# UNITED STATES PATENT AND TRADEMARK OFFICE

APPLICATION NO.	FILING DATE	FIRST NAMED INVENTOR	ATTORNEY DOCKET NO.	CONFIRMATION NO.
10/806,264	03/22/2004	Bruce C. Bacon	BAU03 P-308	1927
277	7590	11/08/2005	EXAMINER	
PRICE HENEVELD COOPER DEWITT & LITTON, LLP 695 KENMOOR, S.E. P O BOX 2567 GRAND RAPIDS, MI 49501			LUGO, CARLOS	
			ART UNIT	PAPER NUMBER
			3676

## Office Action Summary

**DETAILED ACTION**

Attachment #1

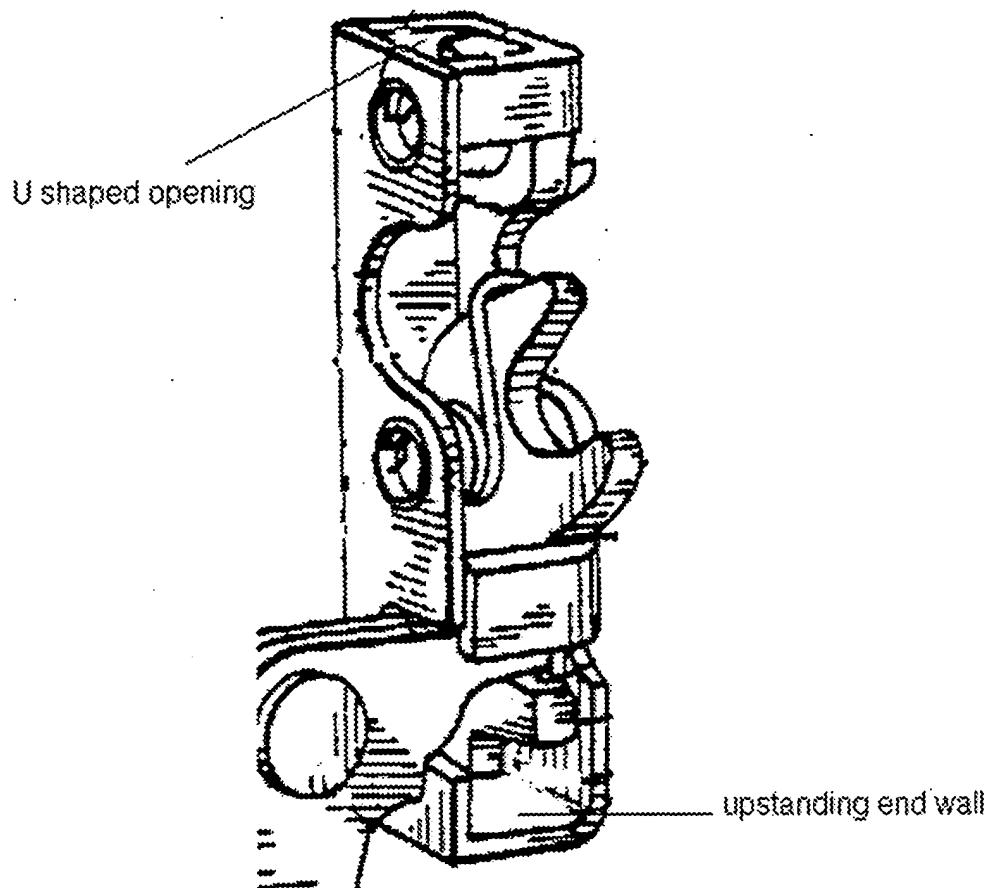
Gleason teaches that it is well known in the art of latches to have a housing (22 and 24) having a generally U-shape, wherein the housing includes upstanding end wall (see attachment #1) formed integrally with the base and the sidewalls at a location adjacent or nearby the strike notches (23) to rigidify the housing.

Gleason teaches that it is well known in the art of latches to have a housing (22 and 24) having a generally U-shape, wherein the housing includes upstanding end

wall (see attachment #1) formed integrally with the base and the sidewalls at a location adjacent or nearby the strike notches (23) to rigidify the housing.
